# ETE Road Map

### Reactor Pressure Vessel Integrity and Pressurised Thermal Shock

### Final Monitoring Report

Report to the Federal Ministry of Agriculture,  
Forestry, Environment and Water Management  
of Austria

Figure 1: Temperatures of wall and cold plume water in reactor downcomer at locations of reactor pressure vessel welds (positions of thermocouples TC10 a TC11 and results from simulation calculations. [HAUEROVA 2000]

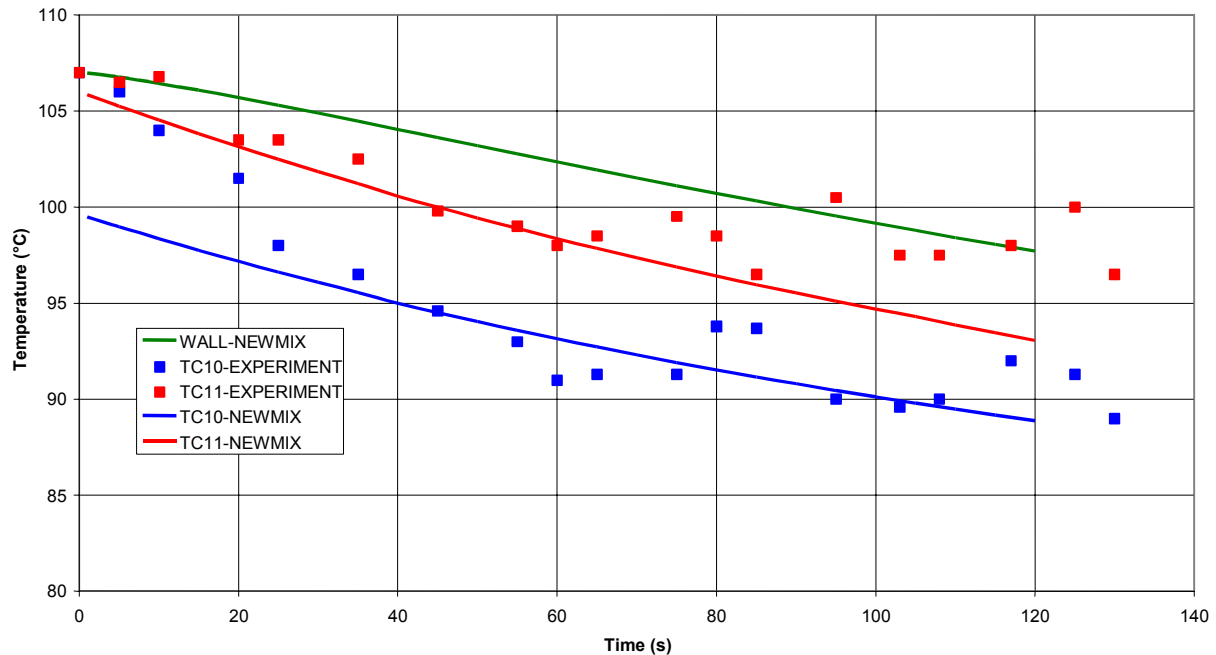
The PTS simulation needs are covered only in part by results obtained with CATHARE simulations for “cold tongues” or better “stripes” – since no radial stratification simulation is possible in the 2-D simulation of the downcomer – and two-phase flow would only be applicable for discrete boundaries as they develop. The coalescent, converging type of flow pattern in the downcomer did not turn up in the exemplary mixing calculations results. These results would be needed to gain an insight into the sensitivity considerations for PTS assumptions.

The wrap-up of mixing simulation results would imply also the need for a more detailed introduction of heat transfer and conduction assumptions made, in order to allow for a consecutive appreciation of the merits of the temperature field development simulation along the transients investigated, in the reactor pressure vessel wall base material, cladding, binding zone and weldment regions as well. The heat transfer parameters mapping to the RPV wall in the respective areas and assumptions about the boundary layer behaviour as well as transition simulation models would be of fundamental interest for proper monitoring (see Figure 1). In an exemplary case provided, the location of the thermocouples for the measurement are not identified, however in both cases, be it the fluid or the wall temperature transient, the comparison suggests at least the using up of all credible conservatism (to less than  $\Delta T = 5$  [K] – in this case) in the first place, even though the implied SIF maximum might arise at the transient reaching the last test readings shown if not later in the continuation not shown with lower ECS flow rates and thus a bulk fraction of “stagnant” primary coolant swapped into the downcomer [HAUEROVA 2000]. In addition, also the statement, that heat transfer parameters are the result of RELAP and ATHLET simulations raise doubts about the soundness of the approach taken. A discussion of boundary layer heat transfer conditions with and without flashing flow and its simulation options as well as the conduct of the transient would eventually also lead to reconsideration, since the scatter of temperatures even before flow and mixing instabilities dominate the DC energy transfer.

Figure 2: FEM model with Circumferential Semi-elliptical undercladding crack,  $a=19,25$  mm,  $a/c = 0,3$ , closer view, lower crack half top view.

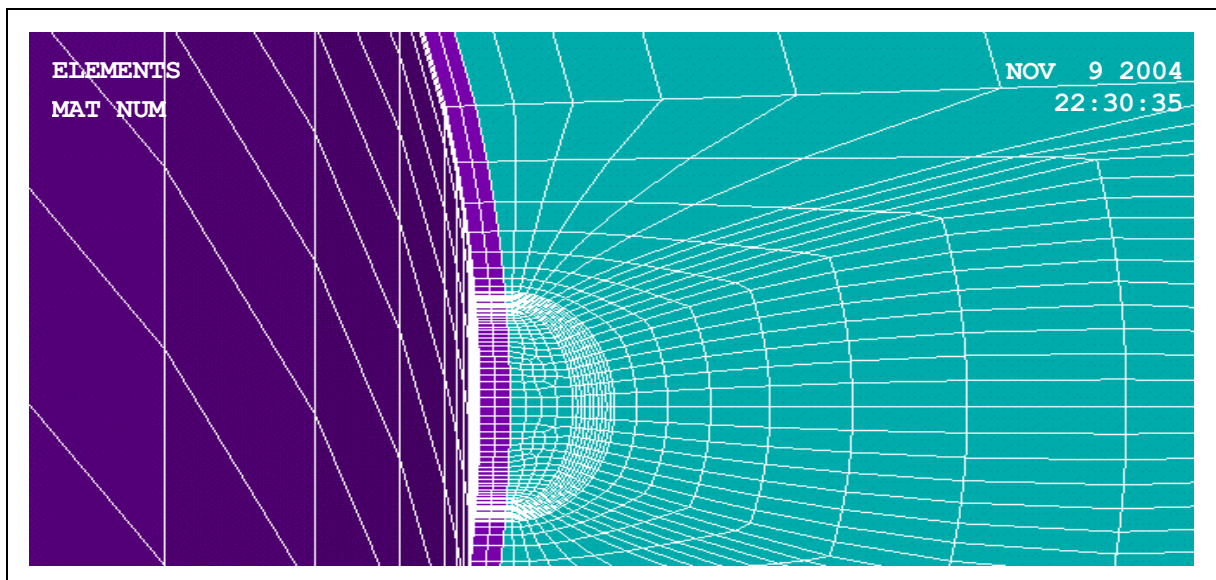
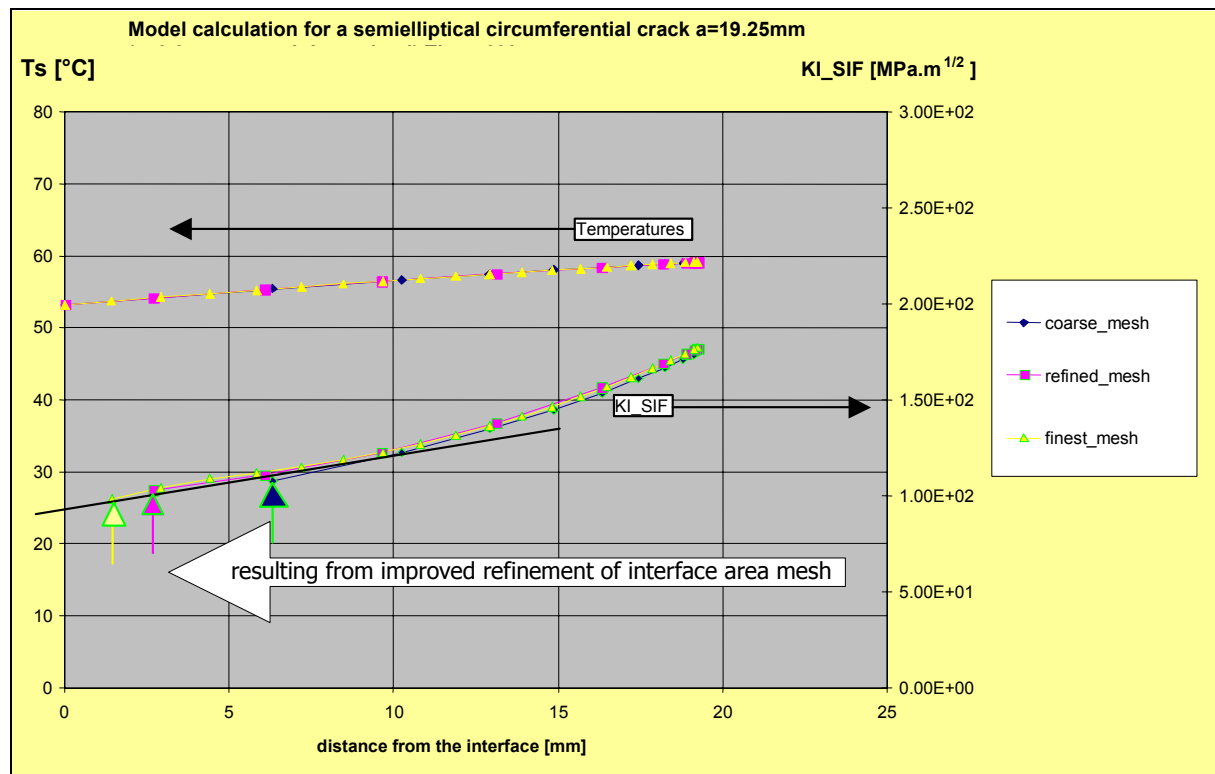
The Czech Experts have chosen unusual procedures for stress intensity factor (SIF) calculations. Using FE-methods for the SIF calculation requires a considerable computational effort. Because of this major computing effort, involved in the integration of the postulated cracks' FE representation into the model, the variation in crack positions and crack geometries calculated is restricted to four different crack depths, two different aspect ratios, two weld positions and two crack orientations. On the other hand, this method allows detailed calculations of the stress intensity factors along the crack front.

The unusual part of the Czech approach is to include the cladding into the SIF calculation (see also paragraph 3.5.2). This requires the assumption that the cladding remains intact with the postulated crack underneath extending only into the ferritic reactor steel [KACOR 2004]. A comparative investigation presented during the workshop in Prague [PISTORA 2004a] included an elliptical underclad crack and a semi-elliptical crack in order to describe the stress intensity factor along the crack front.

It has been brought to the Austrian Experts' attention in the brief presentation of the VERLIFE methodology application, that semi elliptical cracks are the one and only crack configuration to be considered for the ETE PTSA.

Moreover the resorting to a rather unusual simulation that assumes SIF decreasing locally to  $SIF = 0$ , as it has been done in the Czech approach, is contradicted by the results of pilot-case simulations conducted in the monitoring process. Whenever refinement is applied to a mesh inserted for the crack tip at the cladding/base-material interface area the resulting SIF does not exhibit the behaviour assumed in the Czech approach (see Figure 3). This is a clear indication, that the reduction of conservatism is caused by the modelling approach.

Figure 4: Neutron induced embrittlement of ETE materials assuming of the specified embrittlement coefficients as defined in the Russian Code for WWER-1000 materials:  $A_F = 23$  for the base metal,  $A_F = 20$  for welds

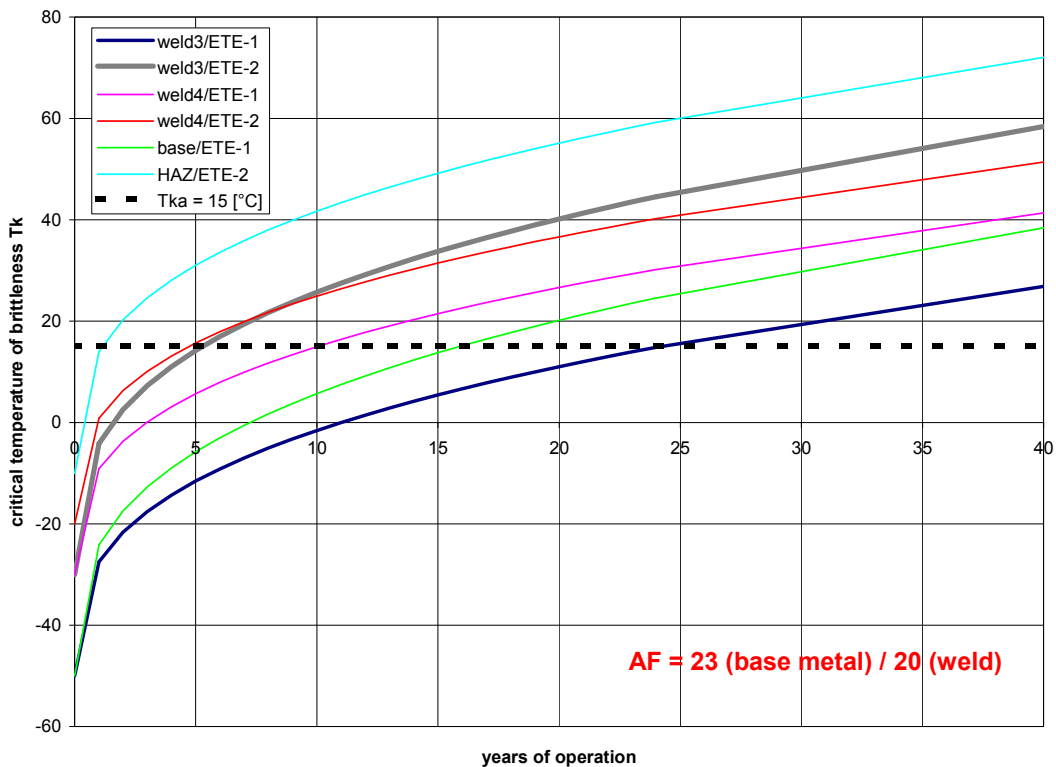
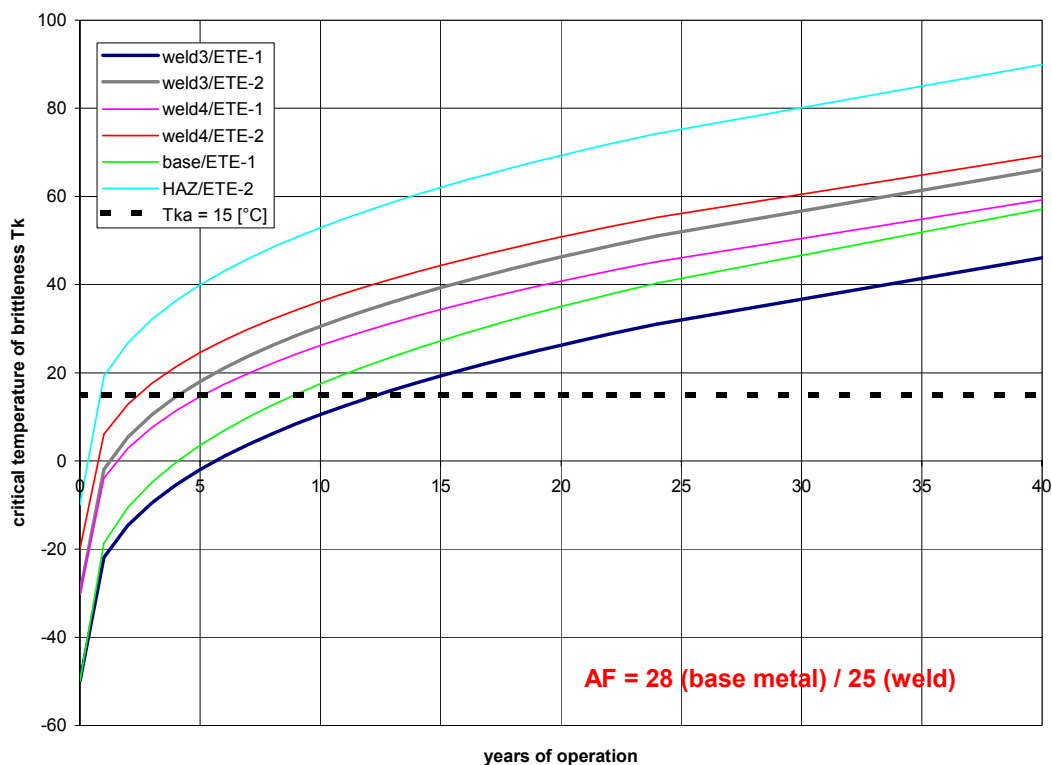
As has been reported, the specified embrittlement coefficients for WWER-1000 materials in the Russian Code cannot be considered conservative. In the next figure the embrittlement curves have been re-calculated for only slightly increased embrittlement factors:  $A_F = 25$  for the weld material (Russian Code: 20) and 28 for the base material (Russian Code: 23). It can be seen that this relatively small change of the  $A_F$  value causes a significant aggravation of the critical embrittlement already in the first 5 years of operation.

It has to be kept in mind that the uncertainties about the true embrittlement of the WWER-1000 materials that will not be eliminated by the first sets of surveillance.

Figure 6: Comparison of fracture toughness curves (“VVER generalised” is the formula used in VERLIFE)

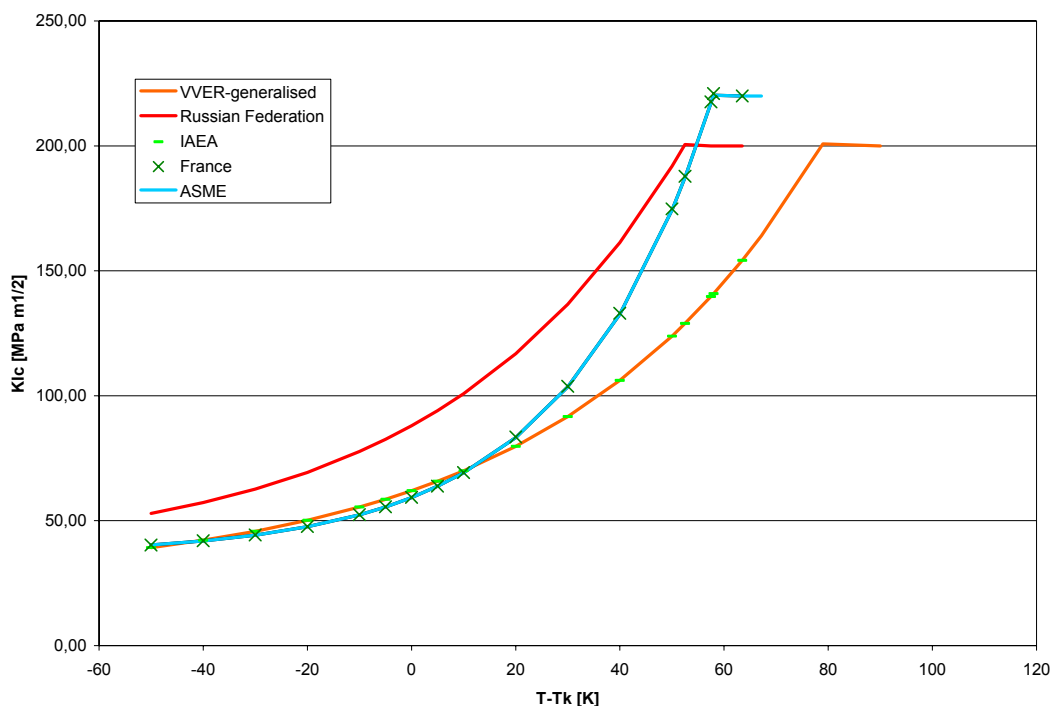
The formula for the fracture toughness curve used in the VERLIFE methodology is identical to the formula given in the IAEA Guidelines. This curve is the most conservative one above about 70 [MPa.m<sup>1/2</sup>]. Below this value the ASME curve is slightly more conservative (see the following figure).

The demonstration of the conservatism of the used fracture toughness curve  $K_{Ic}(5\%)(T-T_0)$  is using experimental static fracture toughness data only from WWER-440 base and weld materials.

Figure 8: TOFD applied to a cladded test block

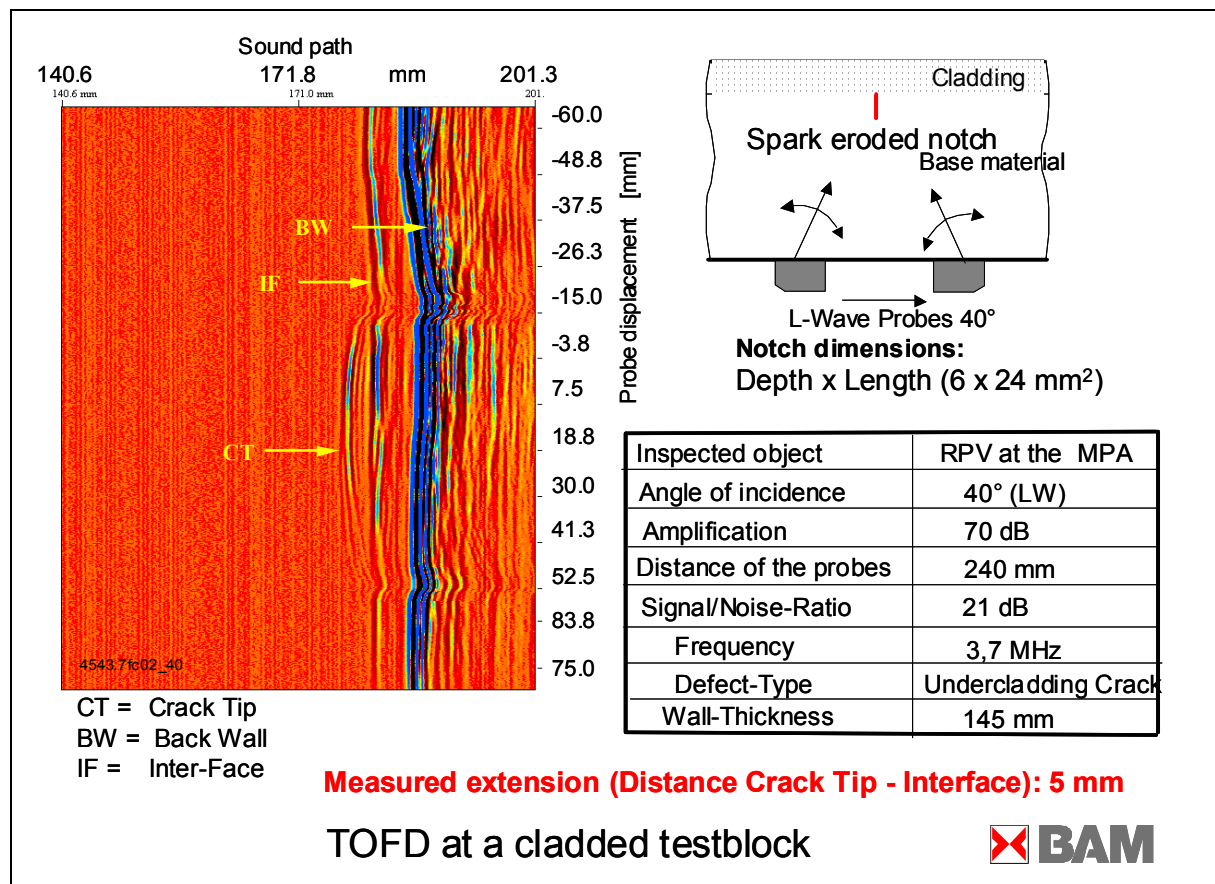
The following Figure 8 shows an example for a TOFD-inspection on a cladded reactor vessel wall with a typical underclad crack type test reflector. One may clearly recognize the upper crack tip and derive from it the depth extension in the base material but it is not possible to say anything about its extension towards the interface or into the cladding.

The qualification procedure for the RPV wall inspection using test sample KB 190 as presented suggest that the scanning and data presentation procedures are optimized during this trial. This assumption is also supported by the fact, that the nozzle inspection procedures are not yet finally optimized. During the visit at the NRI in Řež, Mr. Horáček explained, that the TOFD application qualification had to be repeated because the Škoda operators were not enough experienced with this approach. Although in essence this cannot be criticised, it indicates that the comparability with a "fingerprint" inspection during pre-service may be very limited.

In order to clarify some of the critical items (e.g. the value of the statements concerning the ligament), it has been proposed to use the special NDT workshop in Řež foreseen for October 2004.
